# Technical Service Bulletin

<b>Date: 2014-01-20</b>		<b>SAP DIR #: 20013941</b>	
<b><u>THIS DOCUMENT CONTAINS CONFIDENTIAL INFORMATION</u></b>			
It can be distributed or made available to only those individuals, companies, and organizations which have current Welch Allyn Confidentiality Agreements, and have a need to know.			
<b>Subject:</b>	TSB-CP150 V2.00.03 SOFTWARE RELEASE		
<b>Distribution Scope:</b>	Welch Allyn Global Technical Support, Product , Field & Customer Service and WA ASP's		
<b>Product(s) Referenced:</b>	<ul style="list-style-type: none"> <li>• All CP150 Electrocardiographs</li> <li>• Spirometer Flow Transducer: Lot Codes: 2014 &amp; above</li> <li>• CP150-0030 / SERV KIT, SOFTWARE UPDATE V2.00.03 (with power switch)</li> <li>• CP150-0031 / SERV KIT, SOFTWARE UPDATE ONLY V2.00.03</li> <li>• 20013803 TSB-CP150 V1.00.03 SOFTWARE RELEASE</li> </ul>		
<b>SW Version:</b>	All		
<b>Lot Code:</b>	Spirometer Flow Transducers with Lot Code: 2015 and higher

THIS INFORMATION IS THE PROPERTY OF WELCH ALLYN, INC. AND AS SUCH SHALL NOT BE REPRODUCED, COPIED, OR USED AS A BASIS FOR THE MANUFACTURE OR SALE OF EQUIPMENT OR DEVICES WITHOUT THE EXPRESS WRITTEN PERMISSION OF WELCH

B) Replace the hardware components:

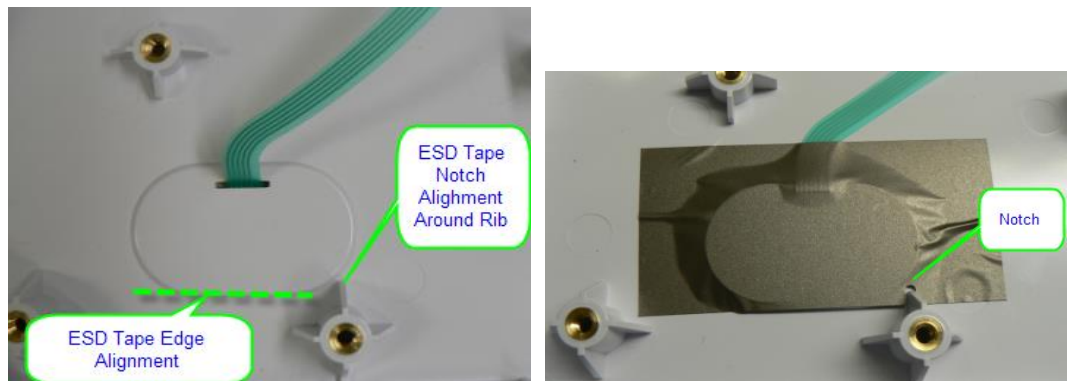
- I. Remove Top Housing assembly from the unit.
- II. Using tweezers, carefully peel the Power Switch Membrane from the Top Housing and remove the Flex cable.

- III. Insert the new Flex cable through the slit in the Top Housing. Remove the adhesive liner from the Power Switch Membrane. Make sure that the liner next to the flex is also removed. Press and secure the Switch Membrane into the recessed area.

- IV. Affix ESD Tape over the underside of the Power Switch and the protruding flex circuit. Align the notch on the screw post rib as shown. Align the edge of the tape around the edge of the indentation for the Power Switch as shown.

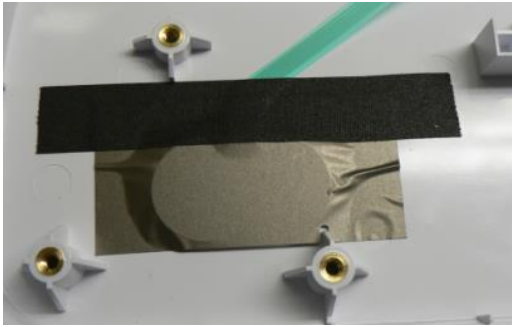
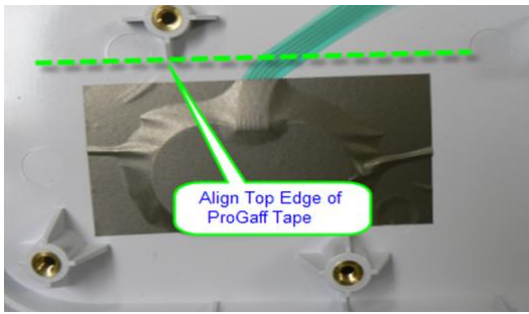
V. Add Pro Gaff tape over the EMC Tape. The Pro Gaff Tape should overlap over the length of the ESD Tape. The Pro Gaff Tape top edge should be aligned just under the screw post rib as shown.
